STATE OF MAINE  
DEPARTMENT OF TRANSPORTATION  
16 STATE HOUSE STATION  
AUGUSTA, MAINE 04333-0016

March 23, 2026  
Subject: Farnham & Osborn  
Bridge Replacement  
WIN: 026109.00, 026111.00  
Location: **Pittsfield**  
**Amendment No. 2**

STATE OF MAINE DEPARTMENT OF TRANSPORTATION	02610900 & 02611100 WIN 26109.00 & 26111.00 BRIDGE NO. 2274 & 2634
FARNHAM AND OSBORNE BRIDGE FARNHAM BROOK SOMERSET COUNTY PITTSFIELD	ESTIMATED QUANTITIES AND GENERAL CONSTRUCTION NOTES
SHEET NUMBER  <b>2</b> OF 40	BRIDGE PLANS

OSBORNE BRIDGE  
FARNHAM BROOK  
SOMERSET COUNTY  
PITTSFIELD  
CROSS SECTIONS

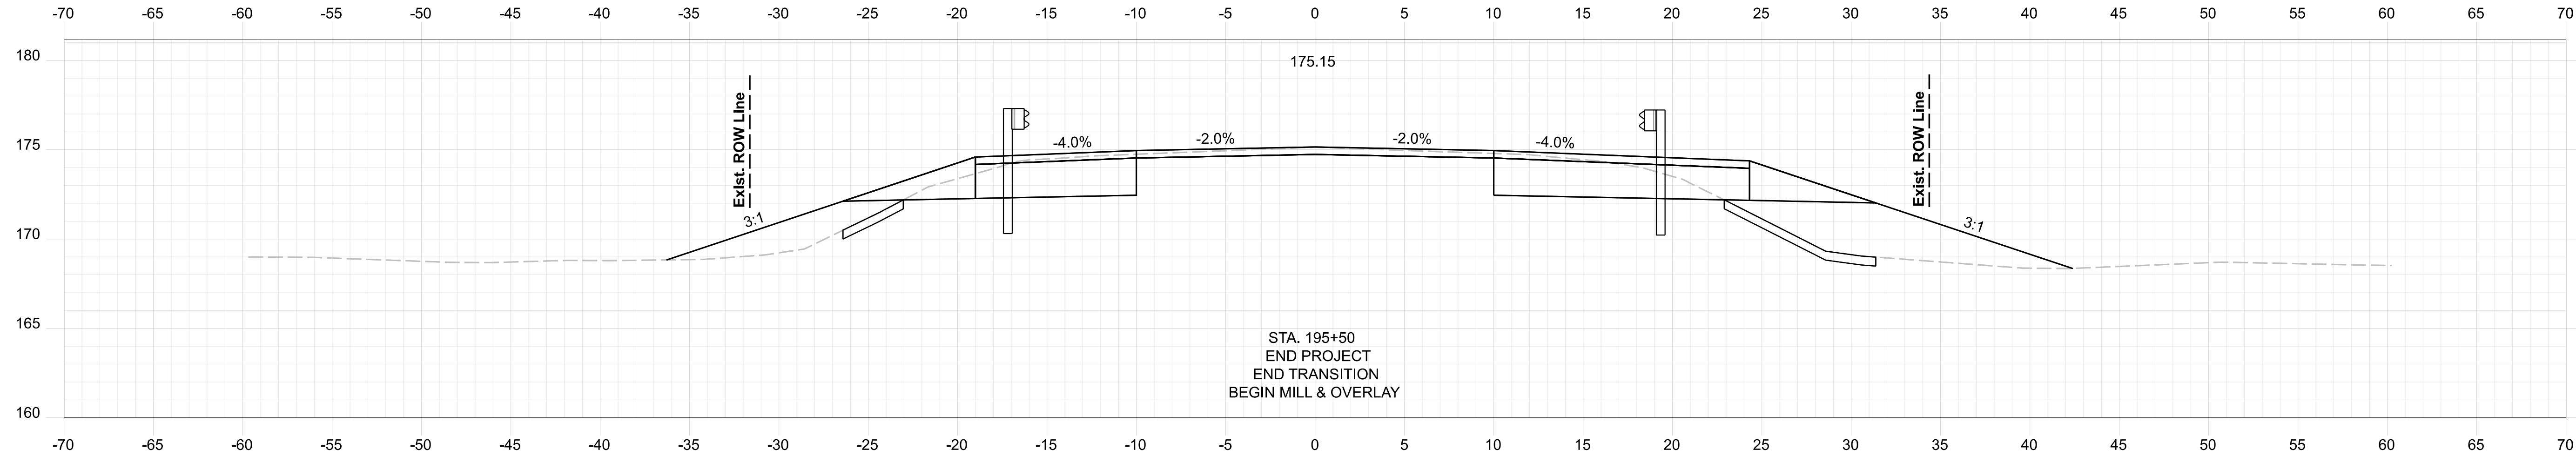
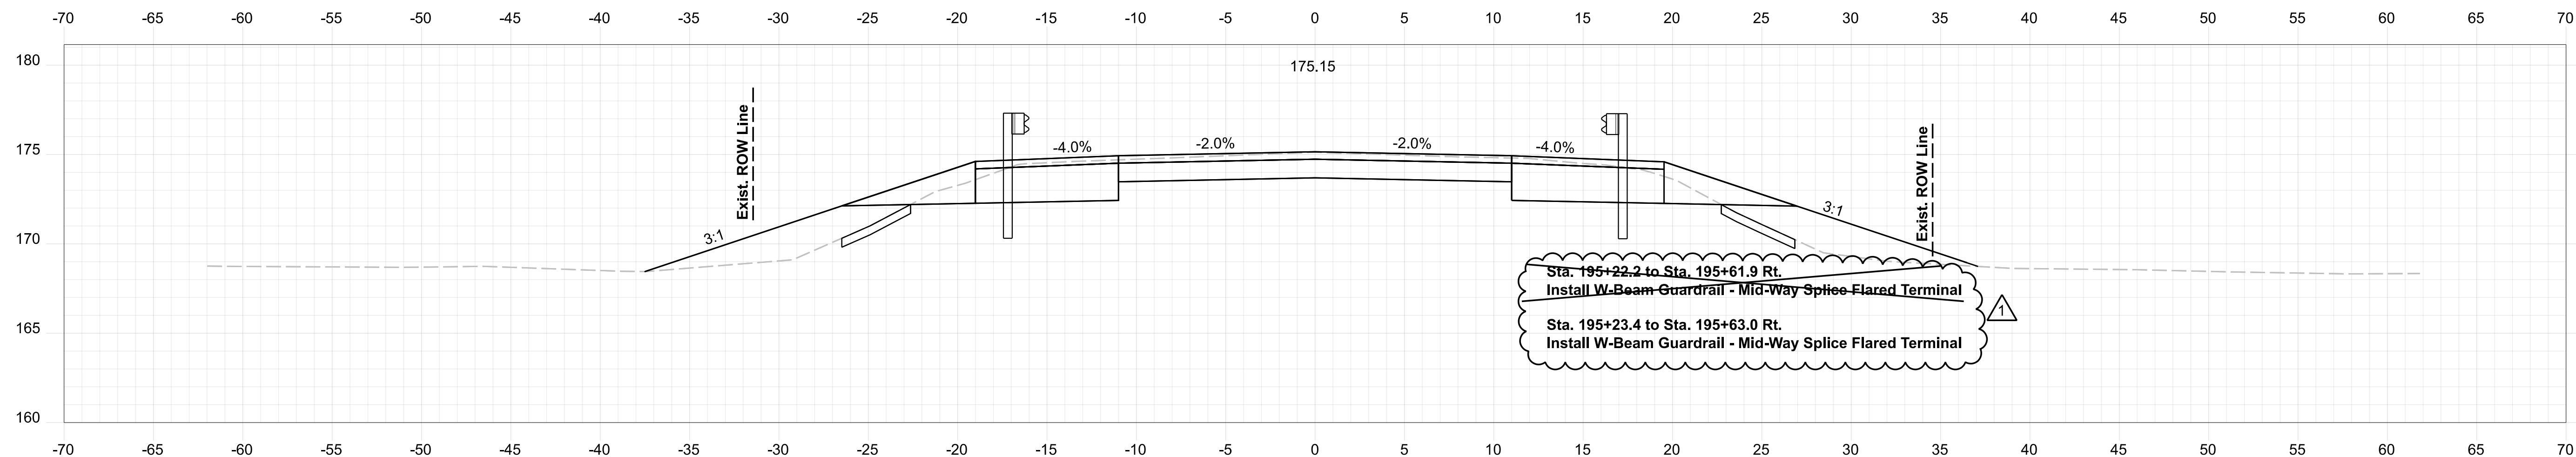
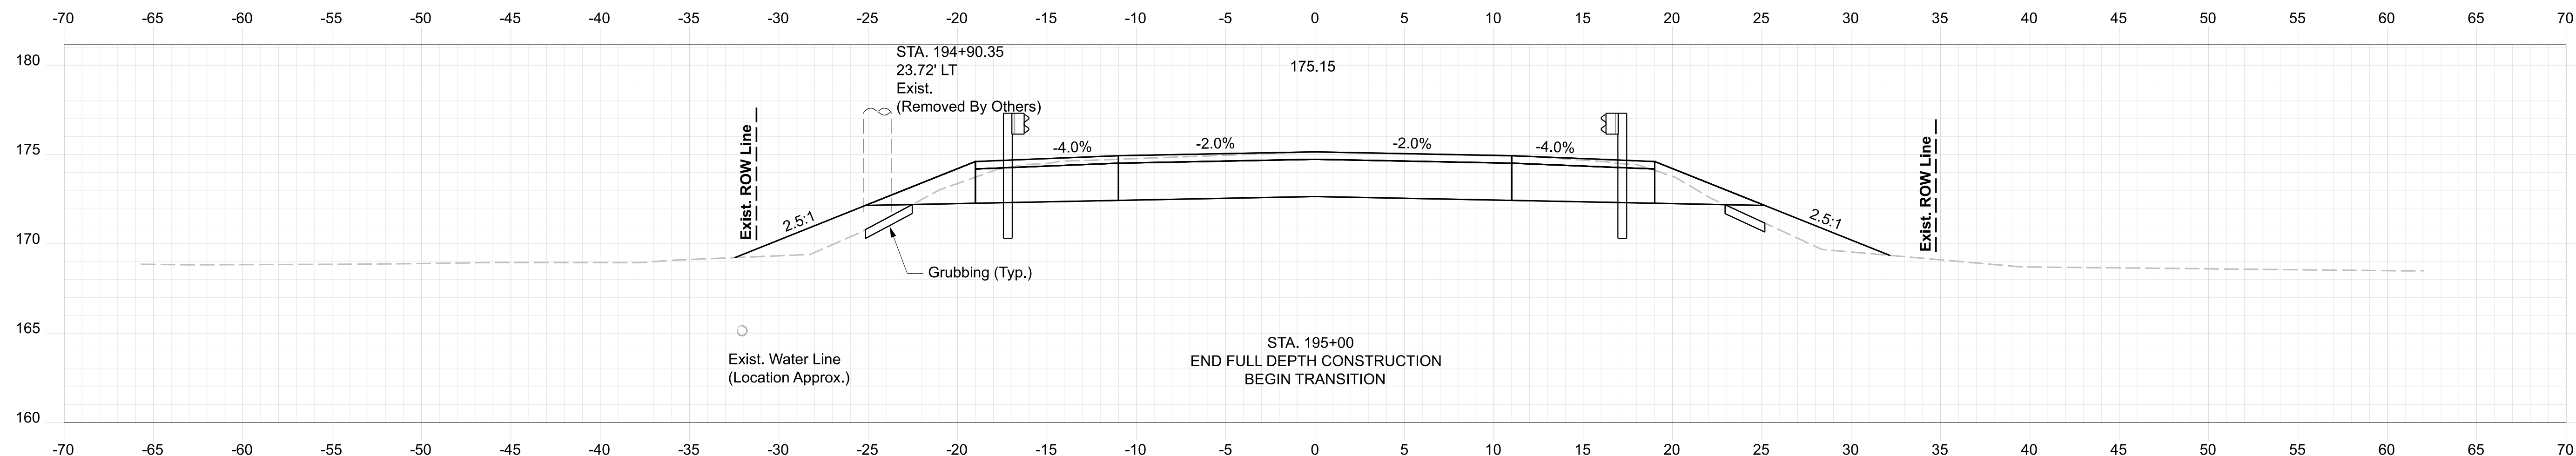
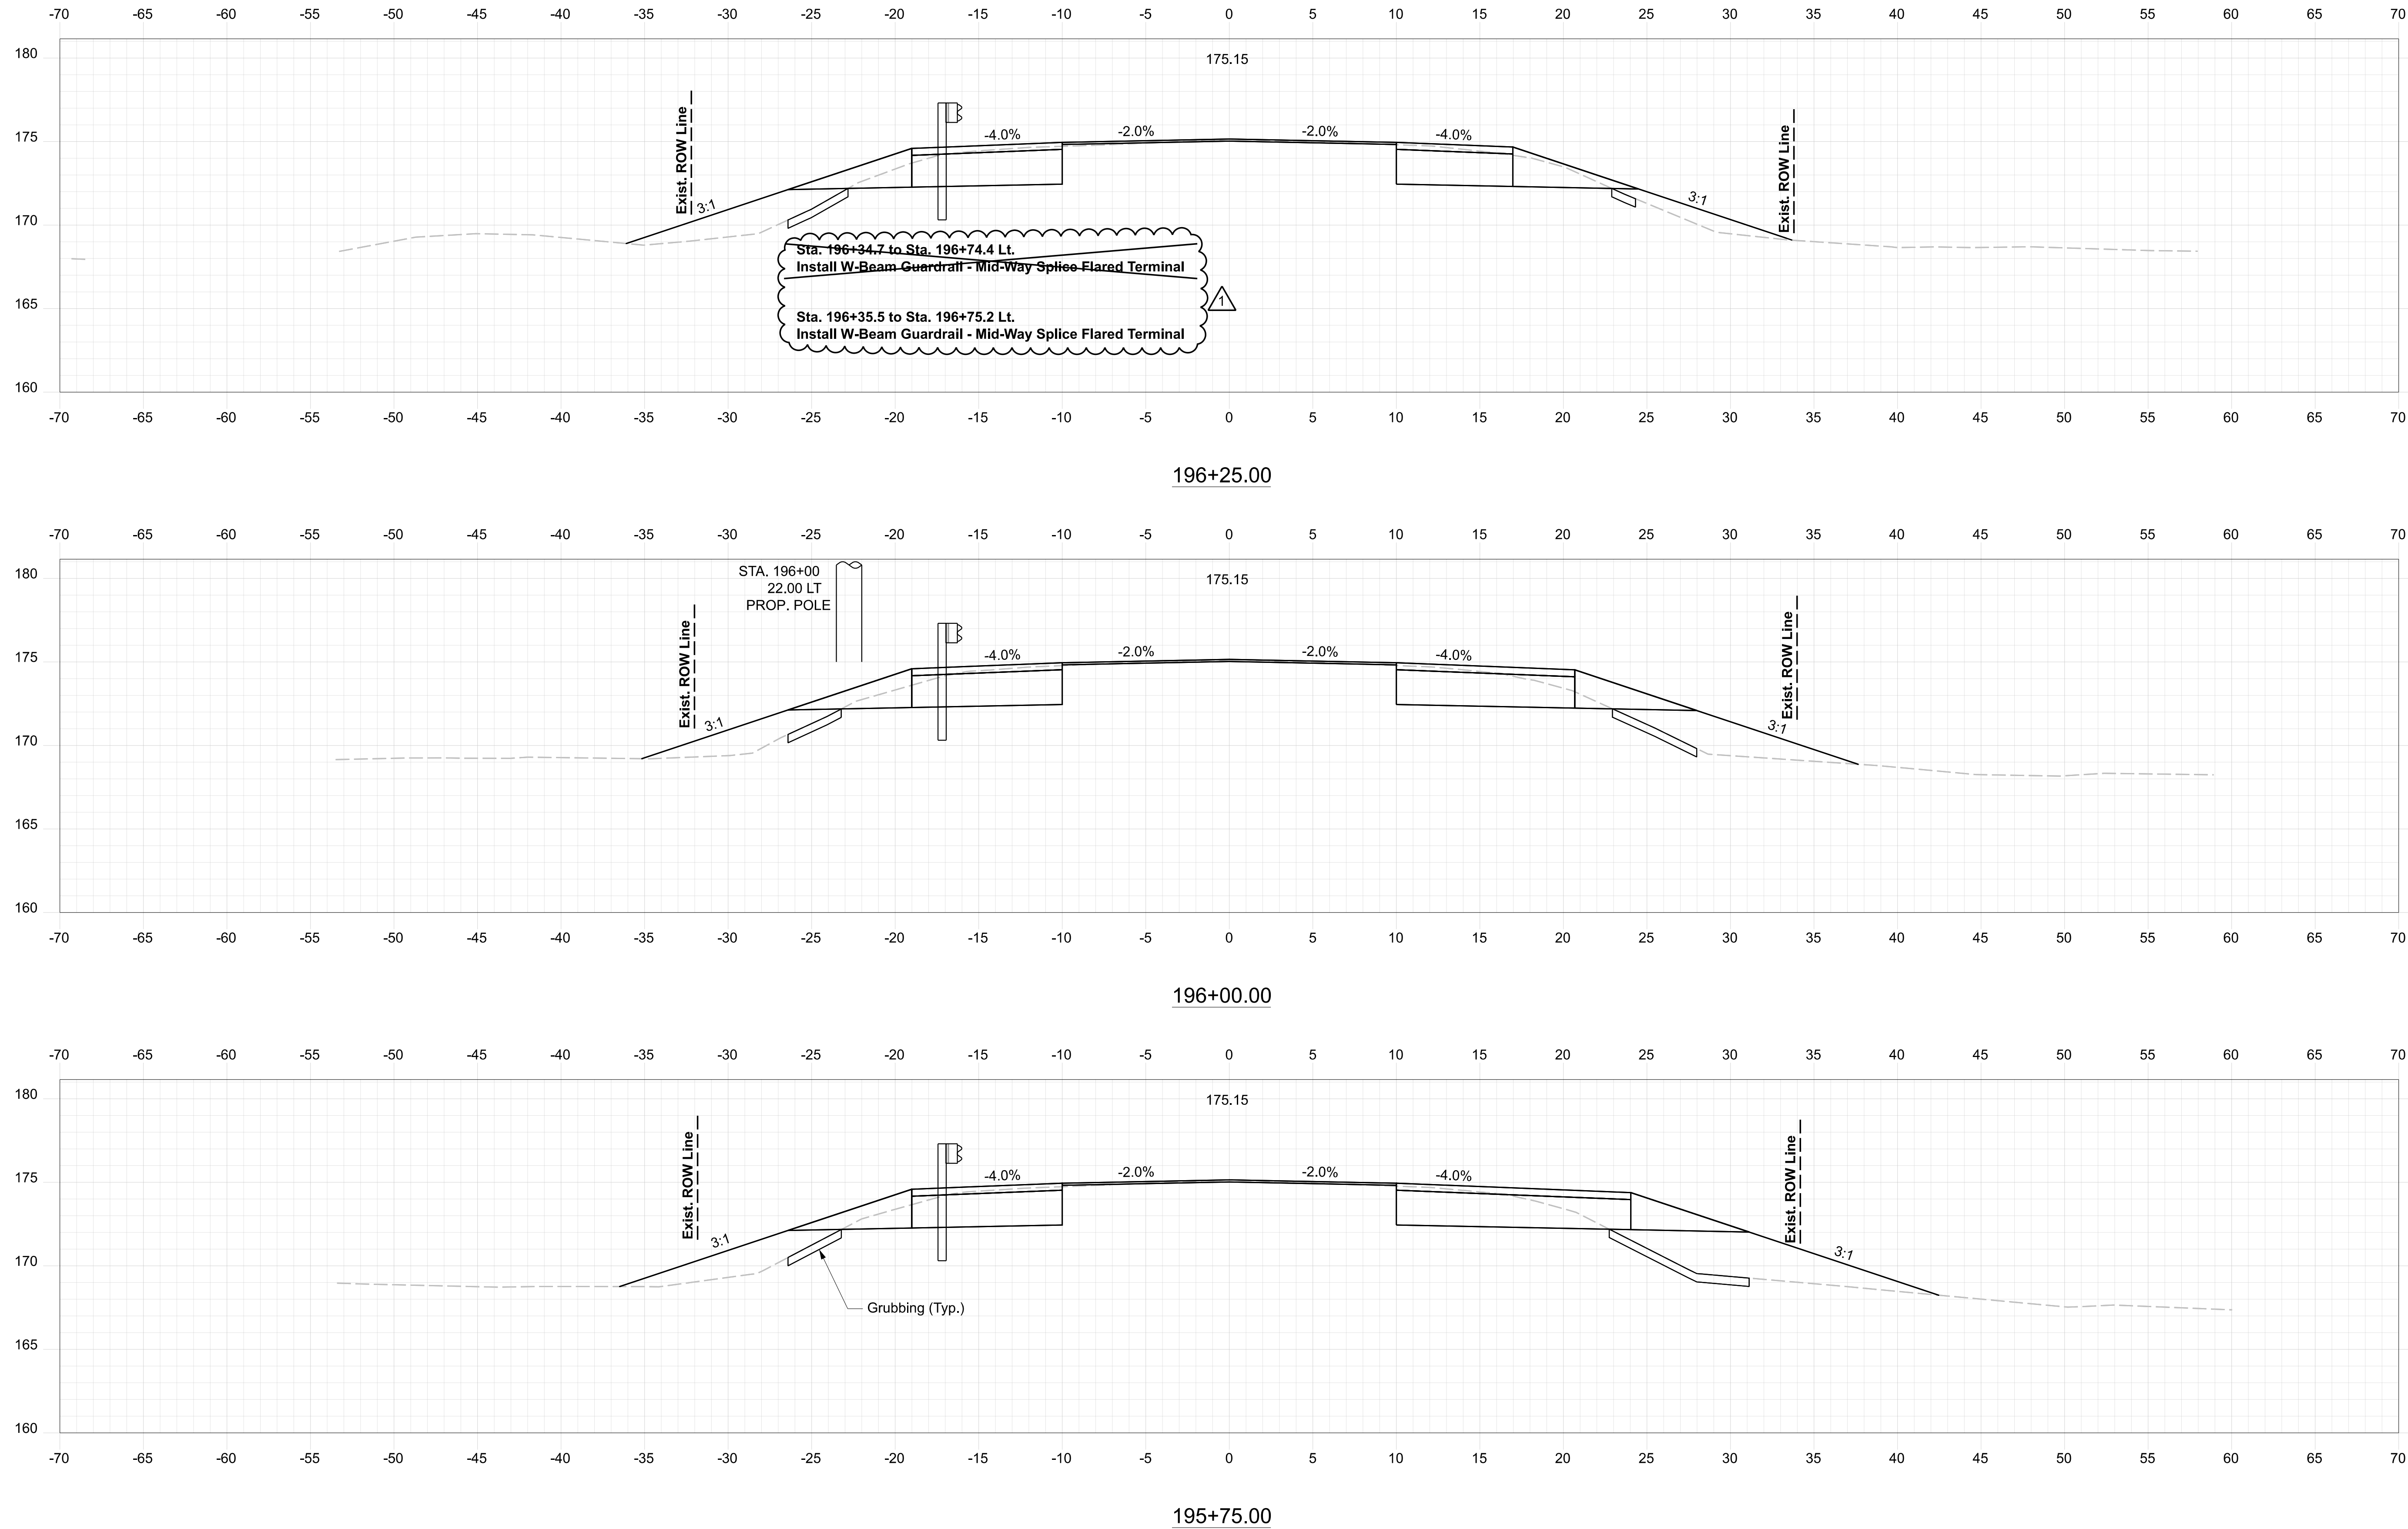
**REMOVE** Sheet Nos. 30, 32-34, CROSS SECTIONS dated February 6, 2026 (4 sheets) and  
**REPLACE** with Sheet Nos. 30, 32-34, CROSS SECTIONS dated March 19, 2026 (4 sheets)

PROJ. MANAGER	BY	DATE
B. NICHOLS	M. SMITH	02/17/26
J. BRICE	D. MUNRO	02/17/26
CHECKED-REVIEWED	S. BEALMONT	02/17/26
DESIGNED-DETAILED	A. YOUNG	02/17/26
DESIGNED-DETAILED	M. BRENZ	02/17/26
REVISIONS 1	CHANGE GUARDRAIL OVER CLAYRT	03/20/26
REVISIONS 2		
REVISIONS 3		
REVISIONS 4		
FIELD CHANGES
